Crna Gora  
Ministarstvo prostornog planiranja,  
urbanizma i državne imovine

## Questions & Answers PITANJA I ODGOVORI

International competition for the conceptual architectural design of  
the Central University Library in Podgorica

Question 1:

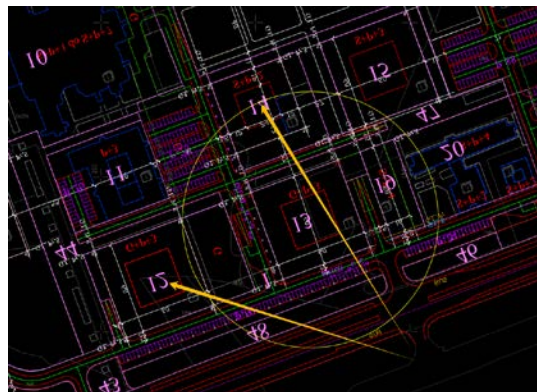
The provided CAD drawings appear to be inconsistent with the current site conditions. Are the CAD drawings based on a future planned state? For the purposes of this competition, should the design be based on the actual on-site conditions or on the CAD drawings? For example, the CAD files indicate a ramp to an underground garage on the east side of the site—should this be taken into consideration in the design?

1. It is necessary to follow the applicable planning documentation.
2. We do not possess a geodetic survey with existing buildings marked on UP12 and UP14.
3. The red line represents a proposed building footprint, which is not mandatory.
4. The indicated number of floors refers to potential future developments that may be constructed on these plots.

Question 2:

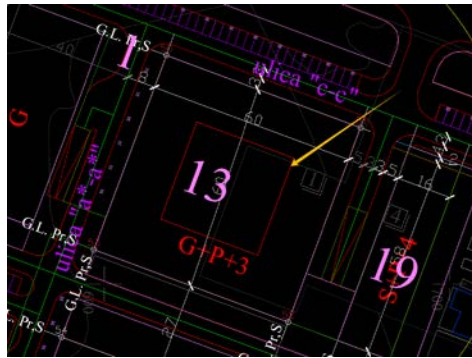
Could you kindly provide the master plan or CAD drawings indicating the building footprints for Plots 12 and 14, as existing structures are visible in the site photos?

Question 3:

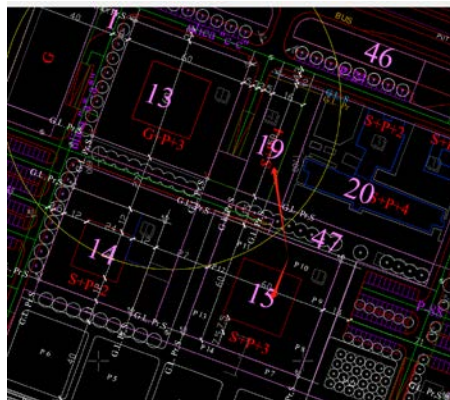
Could you please clarify the specific meaning or designation of the red boundary line indicated in the CAD drawings?
